# SANDY CITY COMMUNITY DEVELOPMENT

## Staff Report Memorandum April 18, 2024

To: Planning Commission  
From: Community Development Department  
Subject: Meek Subdivision (Preliminary Review & Special Exception Review)

SUB02282024-006722  
SPX04052024-006743

Exhibit "A" - Application Materials  
See the attached file for full details

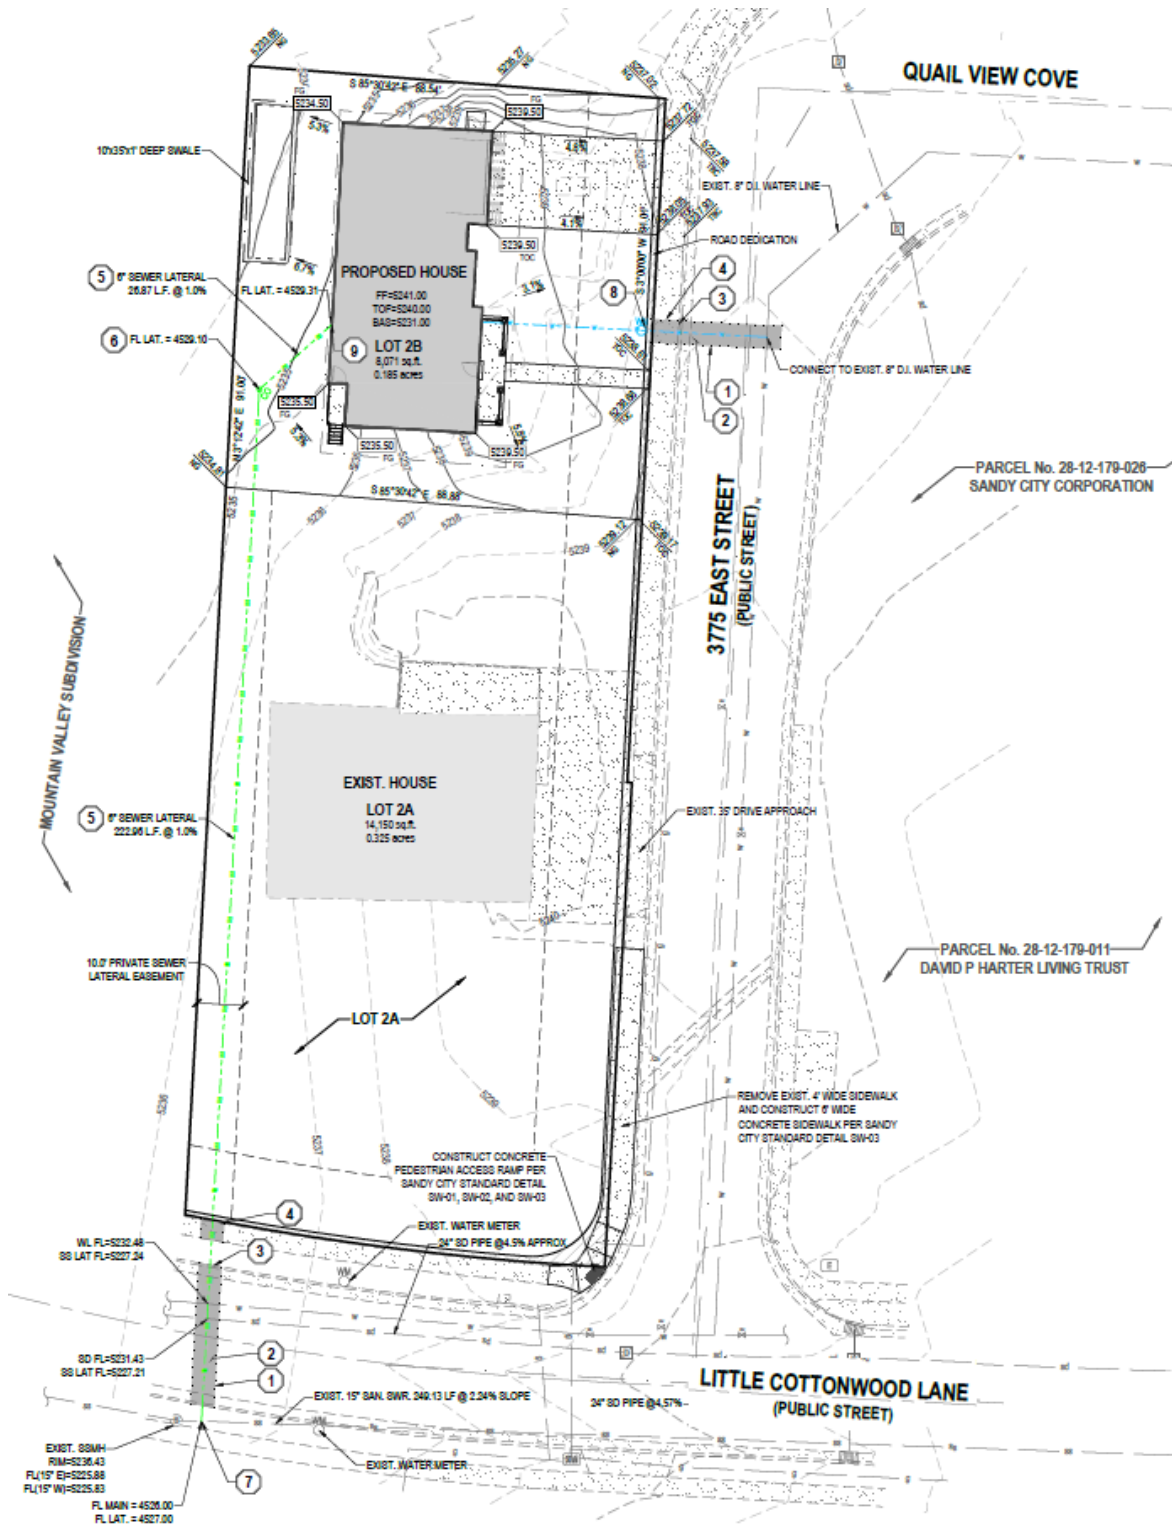
The City Engineer has reviewed this request and agrees that leaving the existing four-foot sidewalk on Little Cottonwood Lane is appropriate along with dedication that would allow for a future five-foot sidewalk. On 3775 East Street, he recommends the existing sidewalk improvements be replaced with a six-foot sidewalk to match the new six-foot sidewalk improvement north of the driveway but supports a waiver of parkstrip and leaving the existing road width as-is. This is based on an analysis of the code requirements listed above and the poor condition of the existing sidewalk and lack of proper cross slope.

Staff believes that the eastern four-foot sidewalk along 3775 East Street should be replaced per the City Engineers recommendations. The existing concrete presents a trip hazard and is not sloped for proper drainage.

The Planning Commission has the authority to waive standard street improvements when conditions listed in the ordinance are met. In this case, the City Engineer is supportive in not requiring the applicant to provide a five-foot parkstrip and a five-foot sidewalk on both sides of the property. Not doing so will be in keeping with the character of existing improvements in the neighborhood. The removal and replacement of the deficient sidewalk on the east side is found to be a necessary improvement that should be required.

It's important to note that improvement and dedication of the six foot walk along 3775 East will result in making the existing home east side setback non-conforming for a corner lot in the R-1-8 Zone. The typical setback would be 20' and this additional dedication will result in an approximate 18' setback to the new dedication line.

- a. That 3775 East Street be further dedicated to a 21.5' half-width public street right-of-way and improved in accordance with Sandy City's standard specifications. That a six-foot sidewalk be installed and replace any existing portions that do not meet this requirement.

- b. That Little Cottonwood Lane be further dedicated to a 26' half-width as a public street right of way in accordance with Sandy City's standard specifications.

- c. That an ADA ramp per City standard specifications be constructed at the corner of Little Cottonwood Lane and 3775 East.
  - d. That appropriate measures be taken by the developer/builder to insure minimal problems with mud tracking and blowing soil/sand during construction.
